COMMITTEE OF THE WHOLE FEBRUARY 7, 2005

**DRAFT PLAN OF SUBDIVISION FILE 19T-04V08
1541677 ONTARIO LIMITED (LIBERTY DEVELOPMENT CORPORATION)
REPORT #P.2004.1**

**DRAFT PLAN OF SUBDIVISION 19T-04V08
1541677 ONTARIO LIMITED (LIBERTY DEVELOPMENT CORPORATION)
PART OF LOT 6, CONCESSION 2, CITY OF VAUGHAN**

CITY OF VAUGHAN
RED-LINED PLAN
(FEBRUARY 7, 2005)

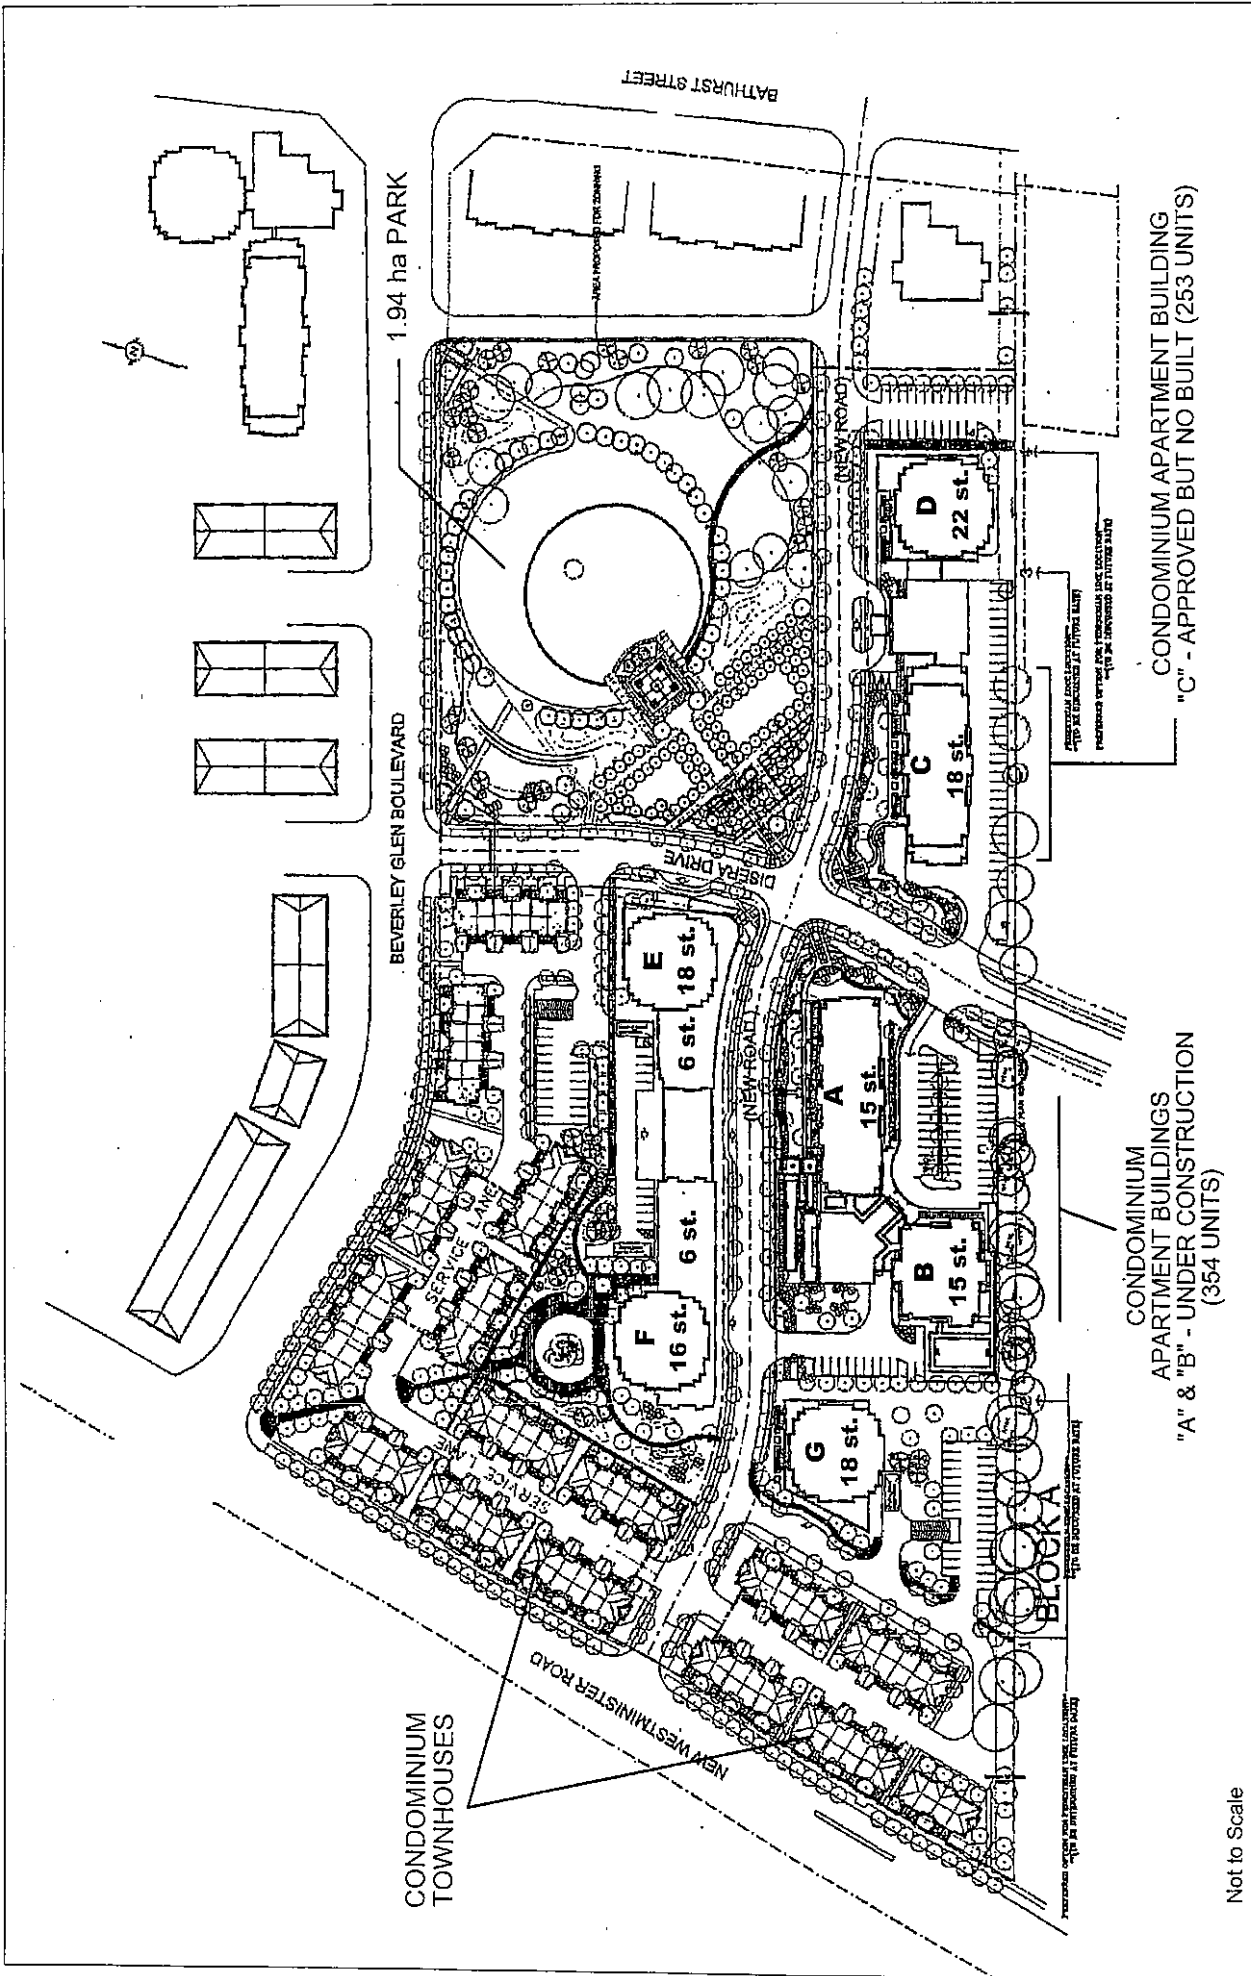
A park block is proposed in the northeast portion of the property and is generally intended to be passive and to include landscaped gardens, pathways, a gazebo, amphitheatre, junior and senior play areas, and a 50 m radius unstructured open space area that could provide future opportunities for the municipality to implement sports fields. A tableland woodlot stand (0.425 ha) has been preserved and integrated with the Park Block (1.515 ha) to form one public open space centre piece with a total area of 1.94 ha in size as redlined on Attachment #3.

1. The Plan shall relate to the Draft Plan of Subdivision, prepared by Malone Given Parsons Ltd., drawing #02-1285, dated May 25, 2004, as red-lined dated February 7, 2005, and to incorporate the following revisions:

- a) provide 0.3 metre reserves along Streets "A" and "B", to be conveyed to the City of Vaughan;
 - b) provide a 0.3 metre reserve along Bathurst Street, to be conveyed to the Region of York and a 15 m x 15 m daylighting triangle at the northwest corner of Bathurst Street and Street "B" to be conveyed to the Region of York;

- c) Block 1 to be separated into 2 blocks: 1.515 ha Park Block and 0.425 ha Tableland Woodlot block.
2. The lands within this Plan shall be appropriately zoned by a zoning by-law which has come into effect in accordance with the provisions of The Planning Act. Particular zoning categories to be applied are as follows:
